**WHITEMARSH TOWNSHIP  
SHADE TREE COMMISSION MEETING AGENDA  
MARCH 3, 2026 AT 6:30 PM (IN-PERSON)**

- Grading Permit # 2026-04 Matthew Seidman; 6128 Butler Pike; Inground Swimming Pool

## 6128 Butler Pike

Pursuant to my review of the updated plan, the following are my comments.

DATE	REVISION	SHEET:
		1 OF 2
<b>SITE IMPROVEMENTS</b>		
<b>GRADING PERMIT PLAN</b>		
FOR SEIDMAN PROPERTY 6128 BUTLER PIKE, BLUE BELL, PA 19422 WHITEMARSH TOWNSHIP MONTGOMERY COUNTY, PENNSYLVANIA		
SCALE: 1" = 30'	DATE: 02/05/2026	
PROJECT: 25-96

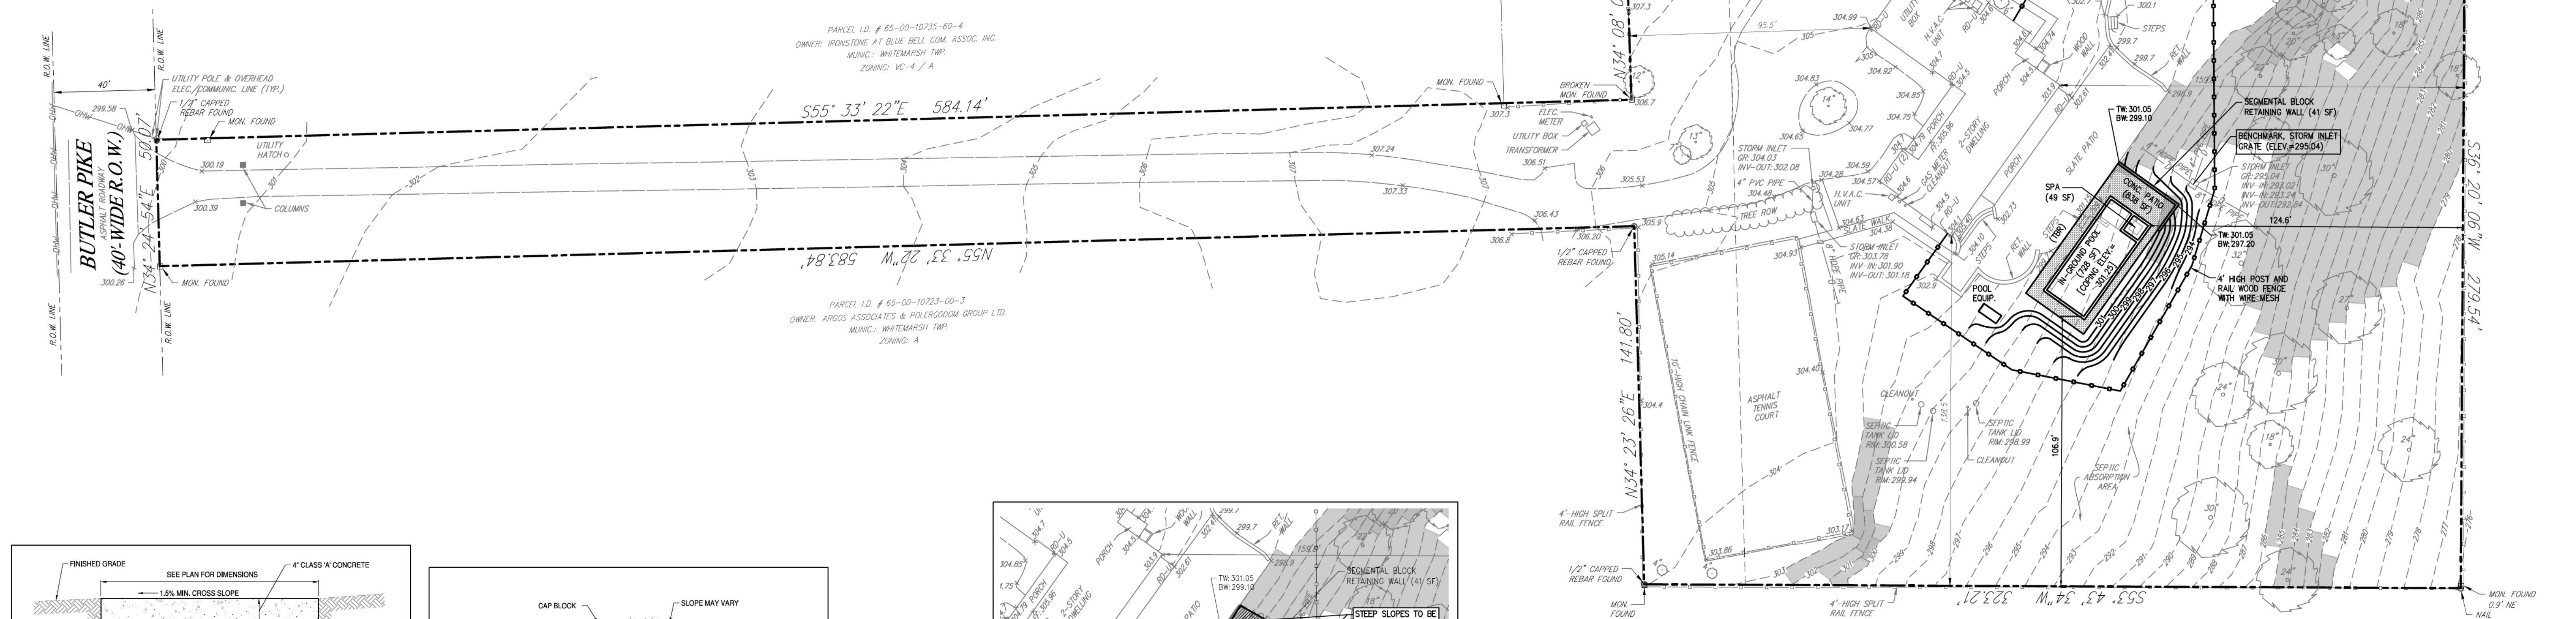
The plan includes an inventory of existing trees; however, only trunk diameters are provided. Tree species are not identified.

Deficiency – Tree Inventory Detail

All inventoried trees must include species identification in addition to DBH (Diameter at Breast Height).

Clarification is required regarding soil handling:

Confirm whether excavated soil will be removed from the site.

If soil is to remain on-site, staging locations must be shown and must not encroach into Tree Protection Zones.

A revised tree inventory schedule shall be submitted listing:

- Tree number
- Species (botanical and/or common name)
- DBH
- Condition (if available)

**PROTECTION FENCING**

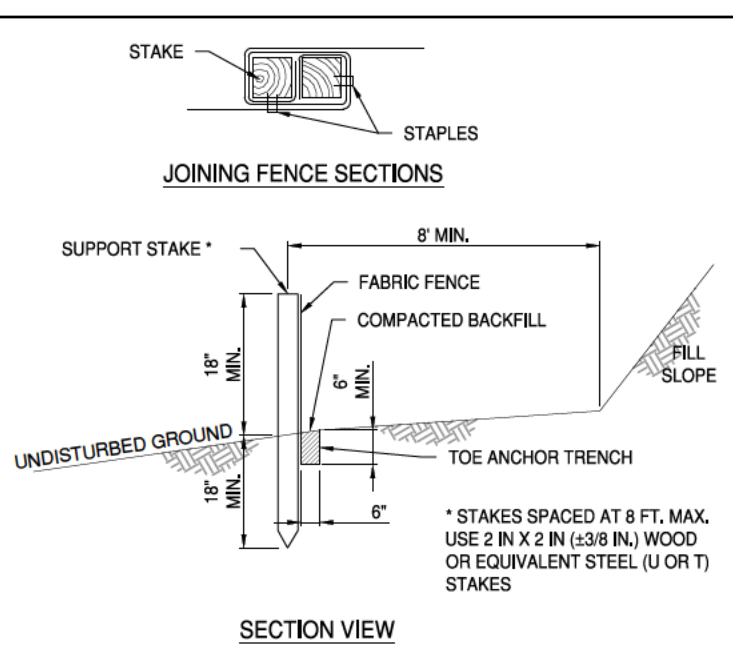
Deficiency – Tree Protection Detail

While protective measures are noted, the tree protection detail as currently shown is incorrect.

The plan references 4-foot construction fencing, which is insufficient for ordinance compliance and field enforcement.

The following is required:

- Installation of 6-foot-high metal chain-link fencing, securely staked
- Fence posts spaced appropriately

- Fencing to remain in place for the duration of construction

A graphic tree protection detail included on the plan set

The detail shall also clearly state:

Prohibited activities within Tree Protection Zones include:

- Grading or soil disturbance
- Equipment storage
- Material staging
- Concrete washout
- Vehicle traffic
- Trenching or utility installation
- Tree protection fencing must be installed prior to any site disturbance.
